Access Compliance Report

Public Rights-of-Way

(Curb Ramps)

Intersection ID: 14213	Main Street: CENTRAL_AV	Cross Street: ROSEHAVEN_DR	Location: SW
ADA ID: 9D1719E99BC5	Ramp Type: Perp	Initial Pass/Fail: Pass	Overall Compliance: No
			Severity Score: 10.25

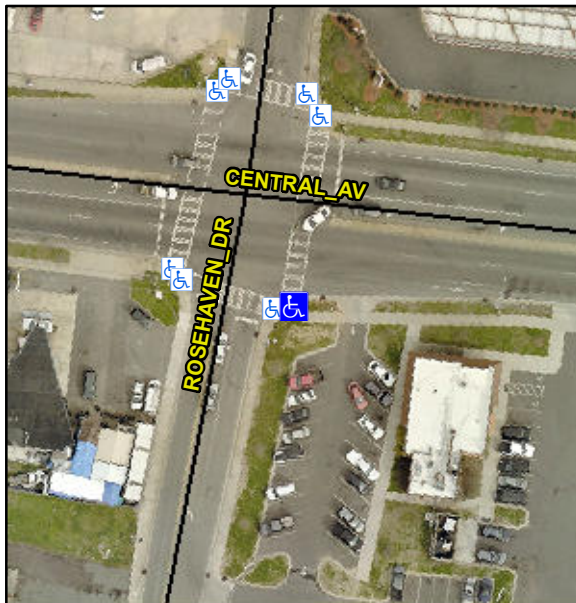
**Not Found, R304.5.3, R304.2.1,
R304.2.2-Perp, R304.3.2-Para, R305**

Compliance	Description	Data	Compliance	Description	Data
N/A	Ramp Length (in)	70.5	Yes	Ramp Slope (%)	6.2
Yes	Ramp Width (in)	49.0	No	Ramp XSlope (%)	4.5
N/A	Flare Type LT	None	N/A	Flare Type RT	N/A
N/A	Flare Slope LT (%)	N/A	N/A	Flare Slope RT (%)	N/A
N/A	Flare Traversable LT?	N/A	N/A	Flare Traversable RT?	N/A
No	Landing Length (in)	45.0	No	DWS Provided?	No
Yes	Landing Width (in)	73.5	N/A	DWS Contrast?	No
No	Landing Slope (%)	2.3	N/A	DWS Length (in)	N/A
Yes	Landing X Slope (%)	0.0	N/A	DWS Full Width?	No
N/A	Landing Curb? (Y/N)	No	N/A	DWS Offset (in)	N/A
N/A	Shared Landing?	Yes			
Yes	Gutter Ponding?	No	Yes	Gutter Slope (%)	3.7
Yes	Gutter Lip Ht (in)	0.0	No	Gutter X Slope (%)	2.6
N/A	Painted X Walk1?	Yes	N/A	Painted X Walk2?	N/A
	X Walk 1 Direction	To N		X Walk 2 Direction	N/A
N/A	X Walk 1 Width (in)	108.5	N/A	X Walk 2 Width (in)	N/A
	X Walk 1 Slope (%)	3.5		X Walk 2 Slope (%)	N/A
	X Walk 1 X Slope (%)	0.8		X Walk 2 X Slope (%)	N/A

**Remove & Replace Entire Ramp.
Remove & Replace Gutter.**
